## PLANNING COMMISSION MEETING

To: **Planning Commission**  
From: **Melissa Sonnek, City Planner**  
Date: **September 15, 2020**

**Case 20-10 – Site Plan Review for the Expansion of an Existing Building at 1700 Marthaler Ln – Maureen Haggerty**

PROJECT NAME: **HAGGERTY, MAUGEN**  
 PROJECT SITE ADDRESS: 1700 MARTHALLER LANE  
 SAINT PAUL, MN - DAKOTA COUNTY  
 BUILDING SIZE: 42'-0" x 48'-0" x 16'-8"  
 SHEET NAME: FACADE MATERIALS ELEVATIONS

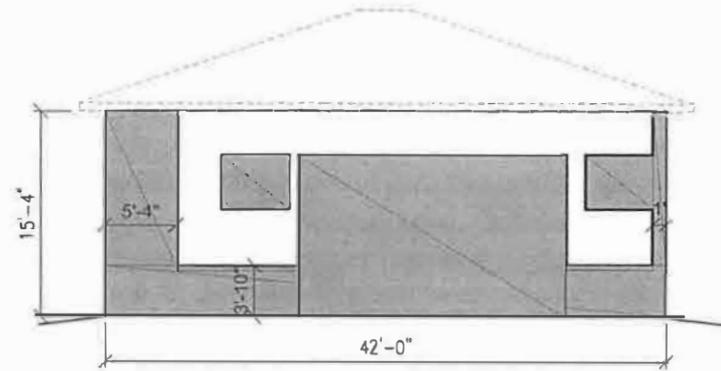
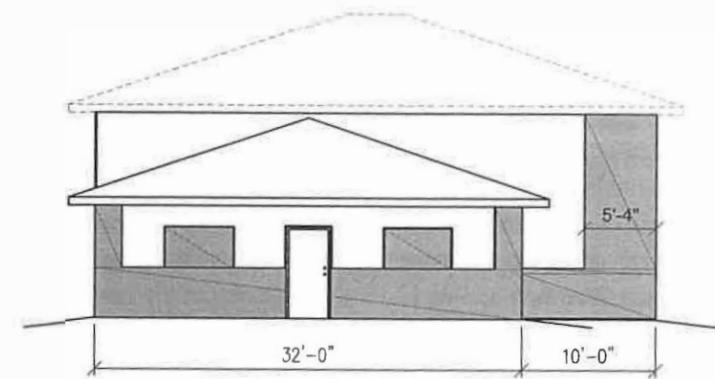
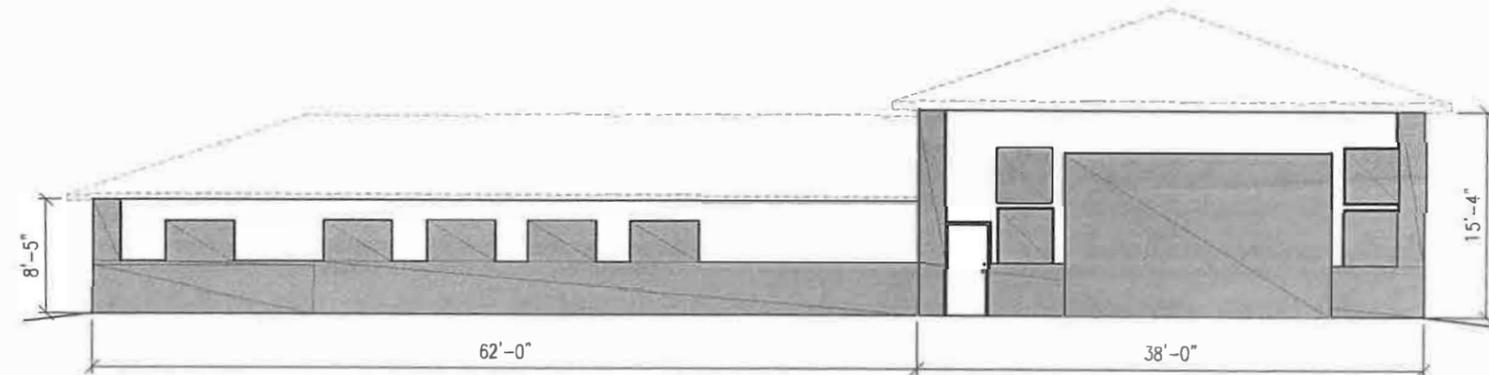
## **Construction Materials/Design**

Code requires that at least 60% of a building be primary materials, such as stucco, brick, glass, or other comparable material; and that no more than 40% per comprised of secondary materials such as colored block, composite wood, or metal paneling. The applicant is proposing a combination of brick (primary), glass (primary), and metal (secondary).

The code also requires visual relief for any building walls that are longer than 60 ft. in length, both the north and south elevations have walls that stretch longer than 60ft. The visual relief requirement can be met by incorporating two of the following items:

- Divide the façade architecturally with different materials or textures;
- Create horizontal offsets of at least two feet in depth;
- Create vertical offsets in the roof line of at least two feet; and/or
- Construction of windows on the first floor that are recessed horizontally at least one foot.

City Staff is recommending as a condition of approval that the applicant incorporate visual relief measures to the north and south elevations.
